Department of Public Works
PARKS AND OPEN SPACE DIVISION

**Cypress Street Playground
Design Review Committee Meeting #4
Meeting Minutes
Room 103-Brookline Town Hall
Wednesday, June 19, 2019 6:00 p.m.**

Playground Enlargement
Concept 4 - Combined
Scale 1"=10'

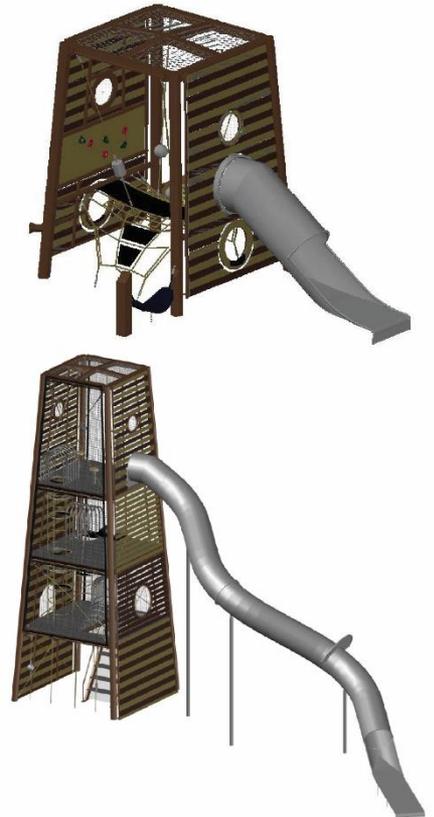
N. O'Connor and Brandon Kunkel discussed concept 4 and where the play equipment pieces would be placed.

W. Sheridan stated that in particular she thinks concept 4 is terrifying. She thinks the LSI custom and LSI traditional has a little less scare factor in terms of safety and protections. She stated that LSI Custom shows some elements that the younger kids will gravitate toward. The balance rope was discussed. She would like to hear more about the material at the gathering area at the basketball courts.

Gideon loves the organic splash pad. He stated that in terms of designs concept he likes 2, 4 and 6. He likes the nests in concept 2, but is concerned about maintenance. He likes the slide in concept 2. He likes the level of multi entry. In concept 4, he likes the fact that it's wood and Intune with the neighborhood. He thinks it look massive but likes idea of something tall. In the Concept 1-5 option, he loves the swings.
